FARRAGUT MUNICIPAL PLANNING COMMISSION

AGENDA

May 19, 2022

SUBJECT: Discussion and public hearing on approval of an outdoor site lighting plan for the multi-family portion of the Farragut Town Center at Biddle Farms project, Parcel 3.22, Tax Map 143, 42.84 Acres, 284 Units, Zoned PCD (Budd Cullom, Applicant)

FARRAGUT TOWNE CENTER @
BIDDLE FARMS - PHASE II
FARRAGUT, TN

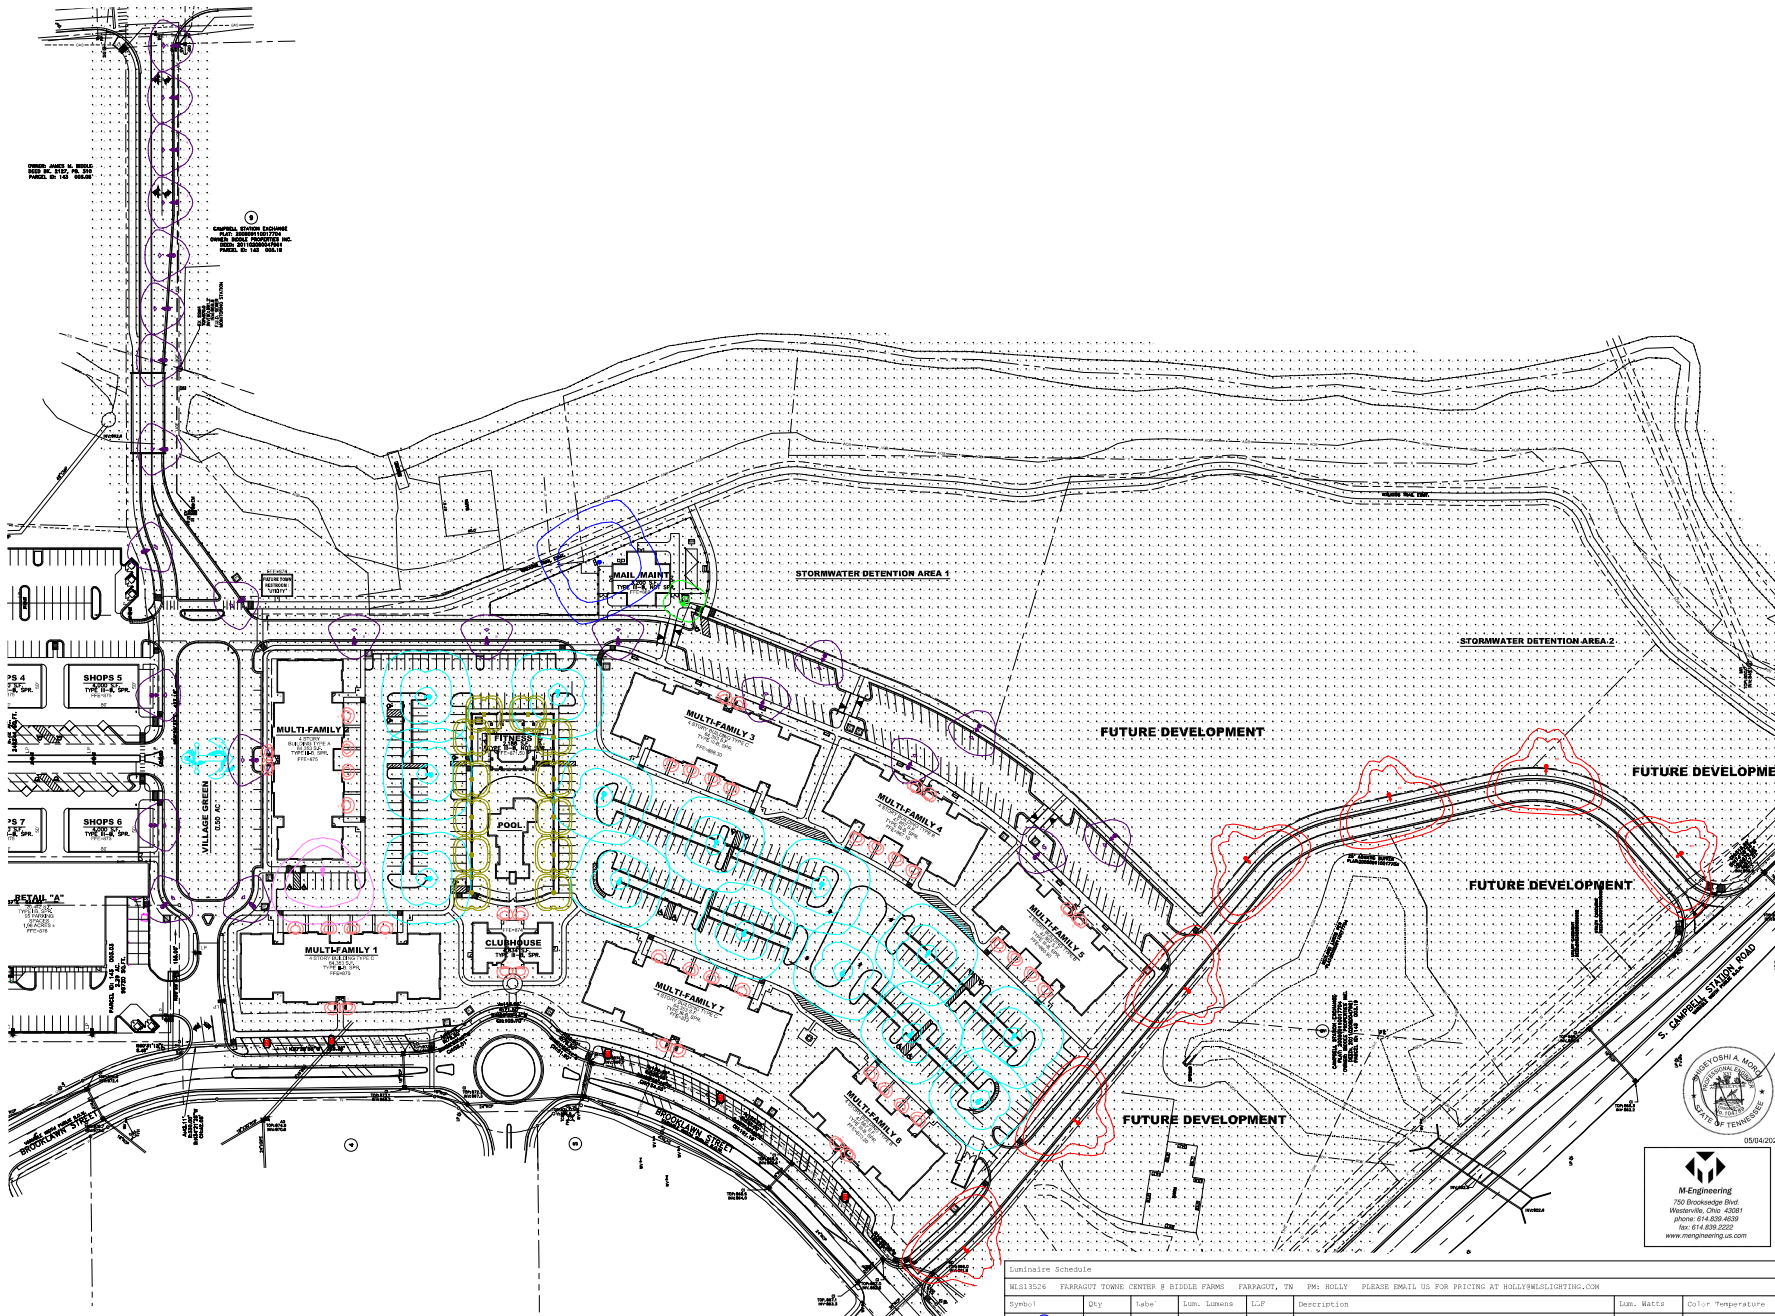
Please include proposed fixture on pole diagram.

Please use color symbols to more easily find the different fixtures on the plan.

Please sign and seal the plan sheets

Please include details for the building mounted lights, including mounting height on buildings.

Please specifically list the Kelvin temperature for all proposed fixtures.

Please include a diagram showing the proposed fixture on the pole.

Please label to correspond to lighting summary sheet.

Please specifically address the plan related submittal requirements in the Town's Outdoor Site Lighting provisions.

Site Plan - Retail Shops

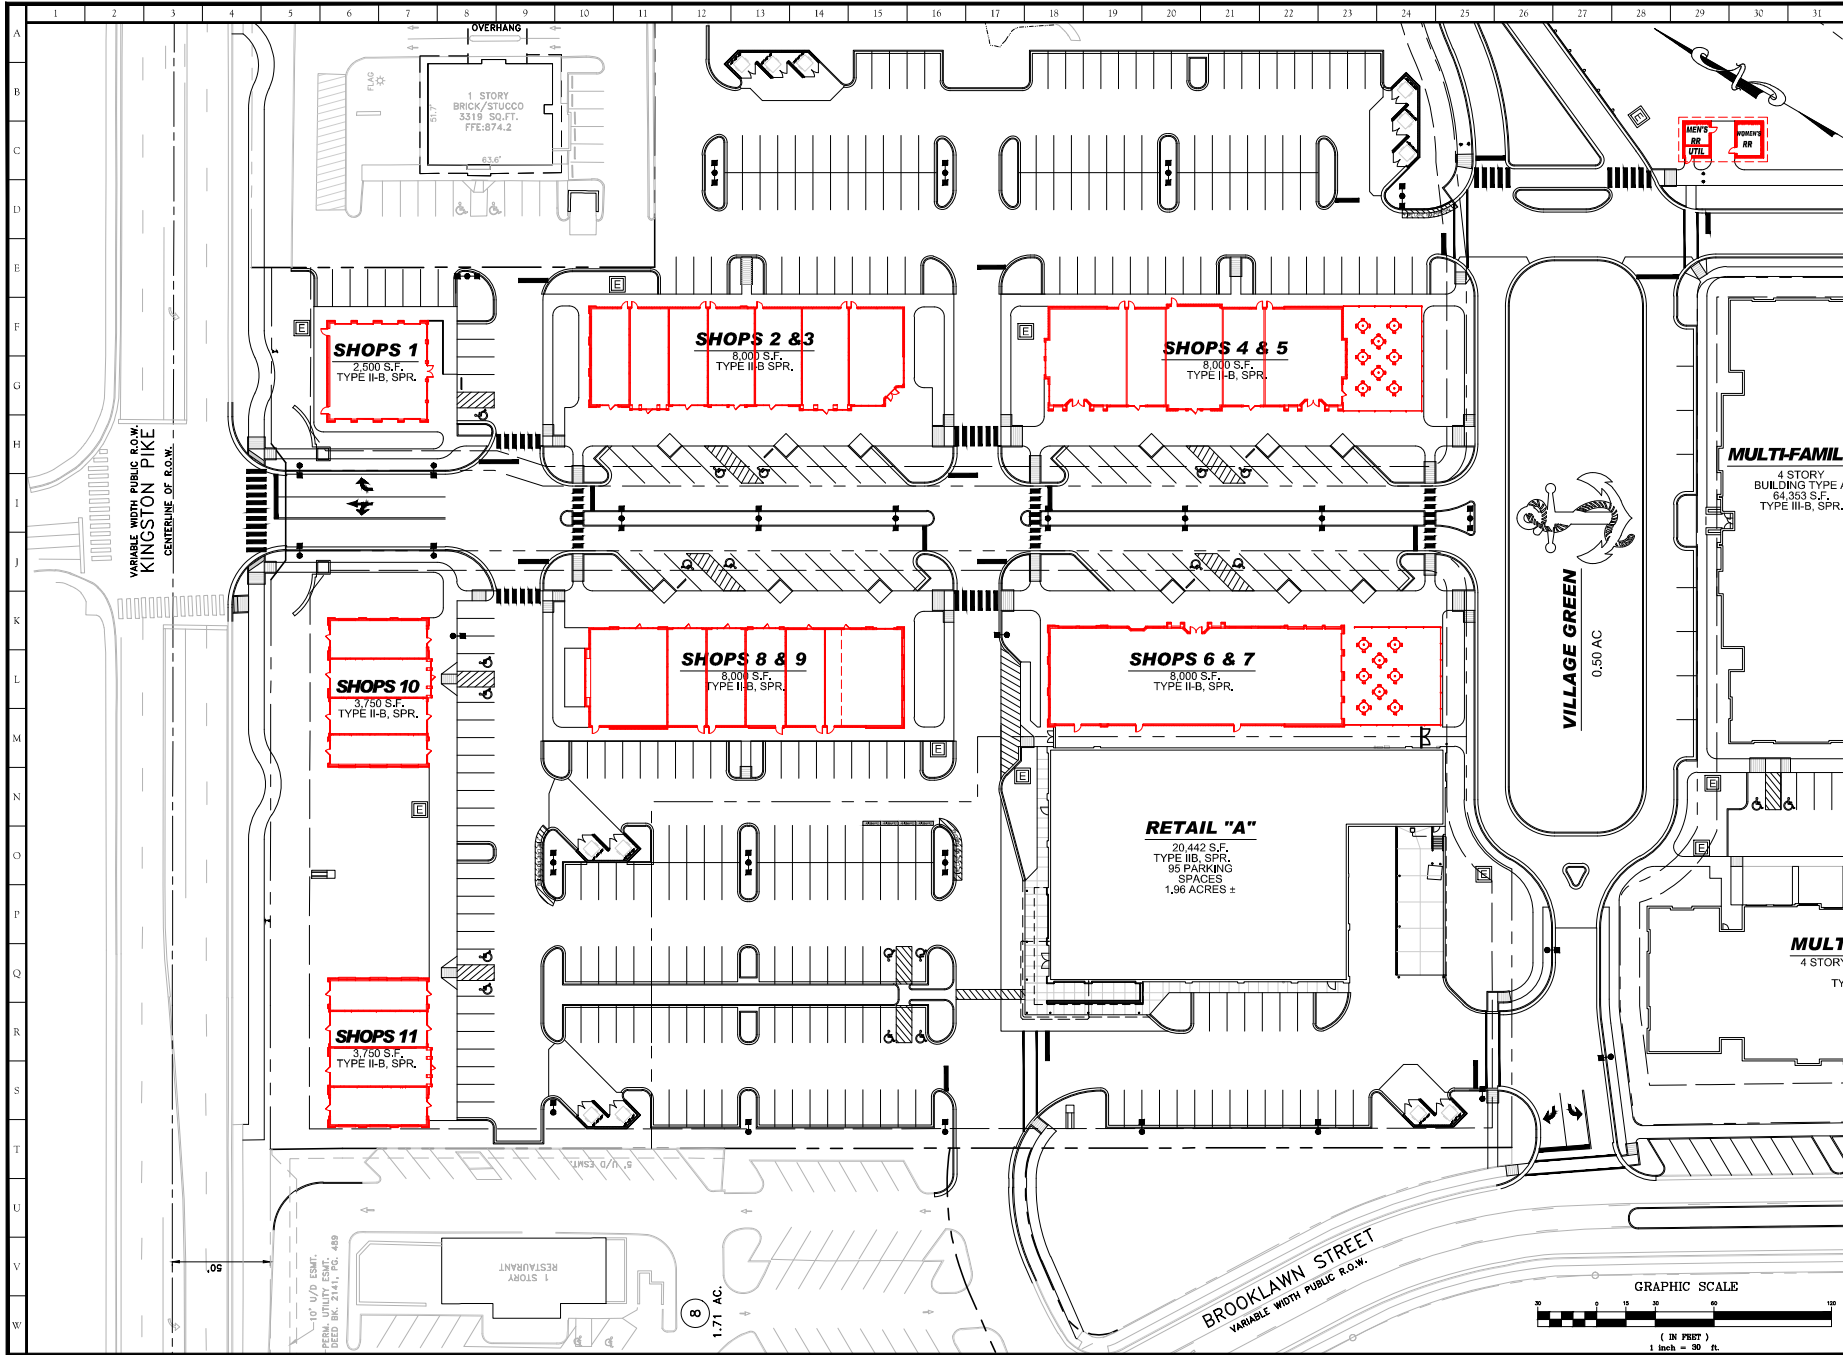
Please make sure key plan matches building layouts.

What type of construction are these?

Identify the type of construction .
Provide height and area requirements.

Please ensure and visually demonstrate that all HVAC units will be screened by the buildings they are serving (e.g. behind a raised parapet).

Please include up to date site layout sheets (building's footprint, relationship to the street, sidewalk, furnishing area, and outdoor seating locations) and site lighting information for the building mounted and other exterior lighting per the requirements in the Town's updated Outdoor Site Lighting provisions.

If possible, please try to ensure that utility structures are located to the side or rear of the buildings and not in more visible and active public spaces.

Will access to roofs be provided via interior stairs or exterior mounted ladders ?

Where will HVAC equipment be located ? Roof ?

For the building elevations, please describe them in terms of North, South, East, West so the buildings can be assessed in terms of how they will appear from different views.

Site Plan - Townhouses

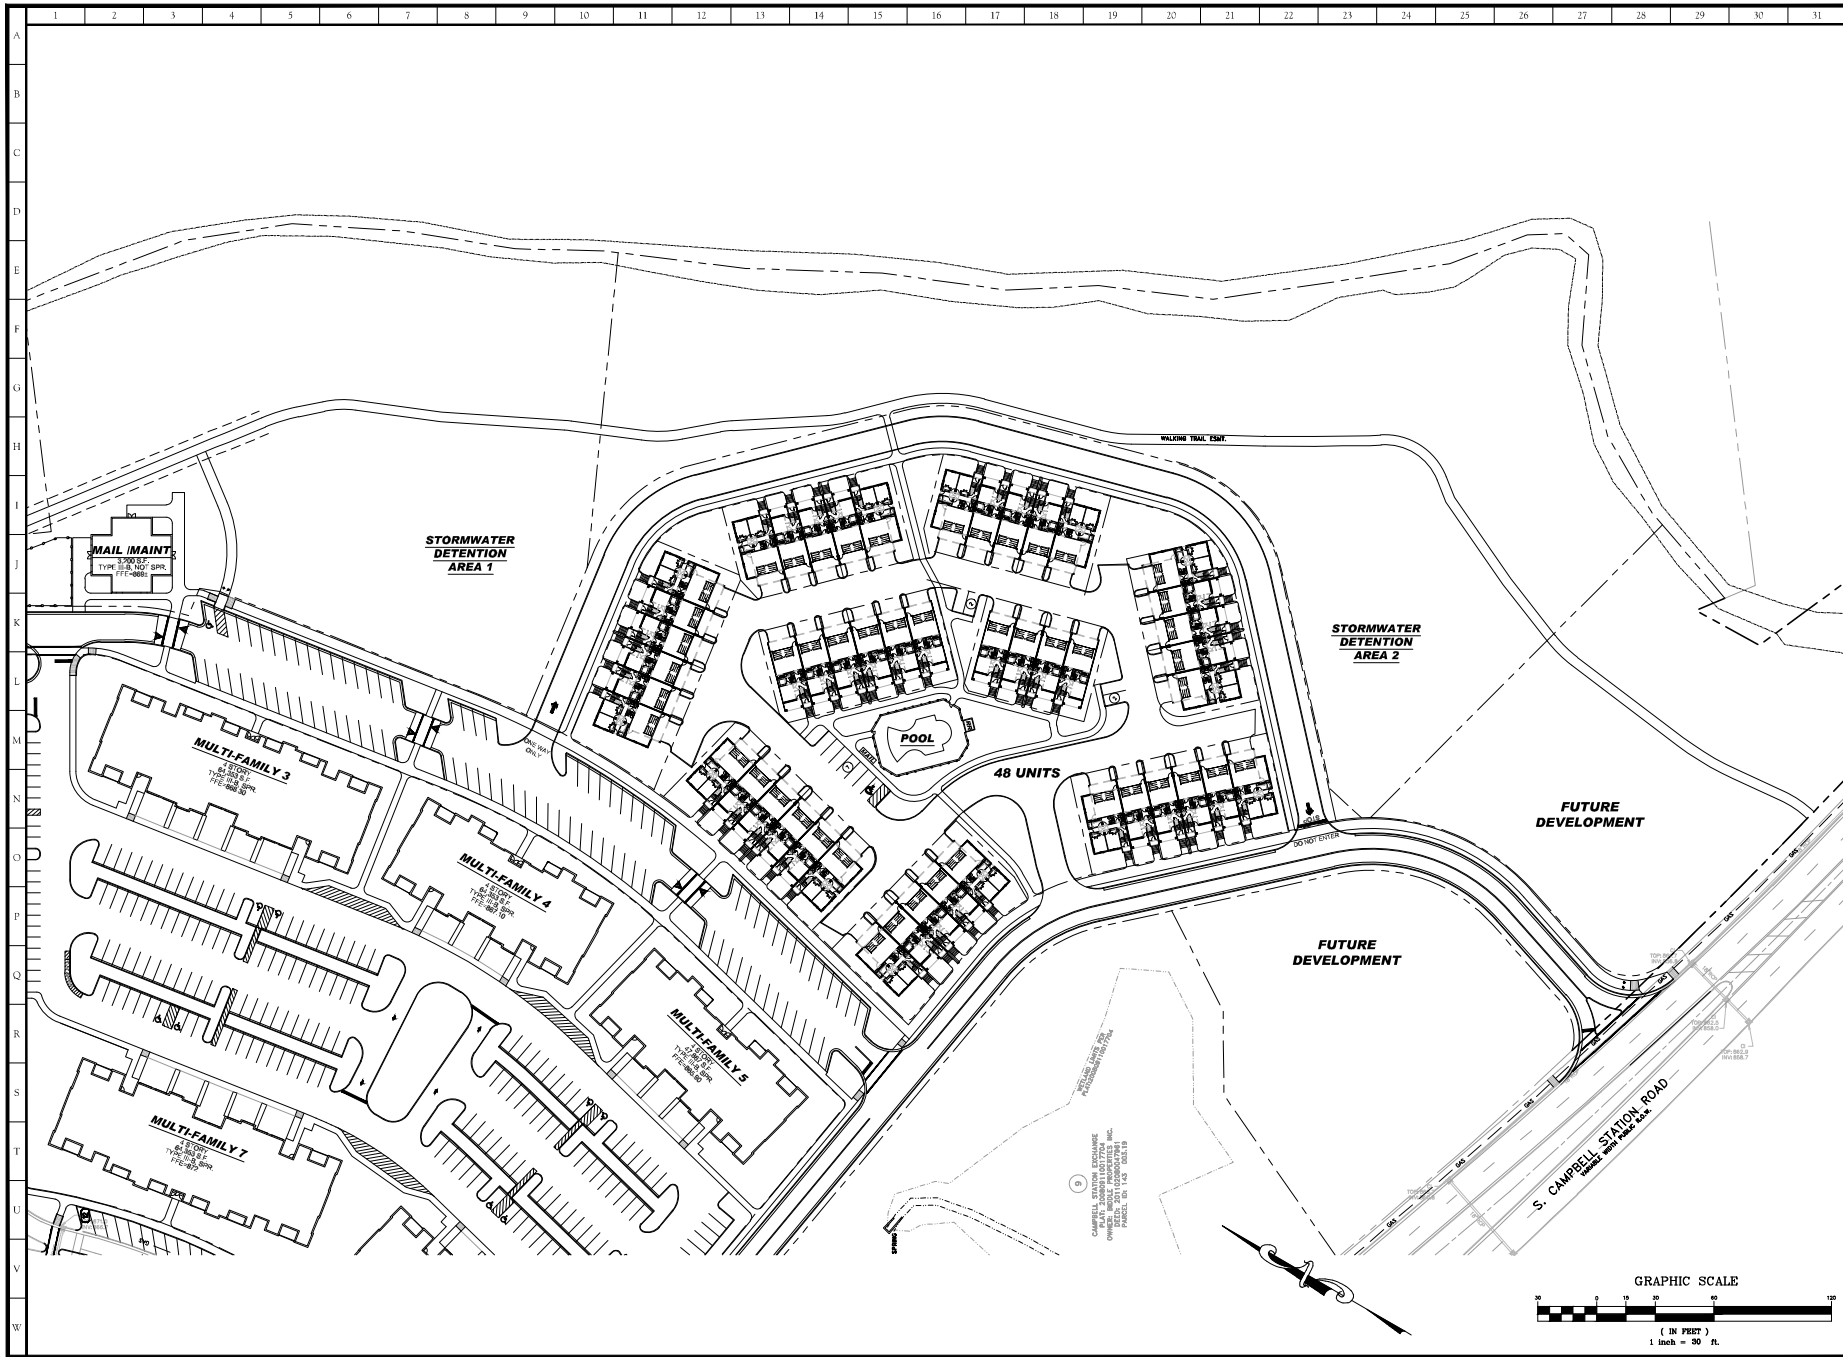
Show construction type.
Provide height and area calculations.
Show the tenant wall ratings.
Elevators must meet all code requirements.

Please show all building elevations and their orientation N, S, E, W.

The narrative (community objectives achieved with this project addition), legal documents, and phasing associated with the rezoning document will need to be updated to reflect this proposed addition. In general, please include and update the required information associated with the original application for rezoning to PCD. This would include updates to the concept master plan per the items required in the PCD District.
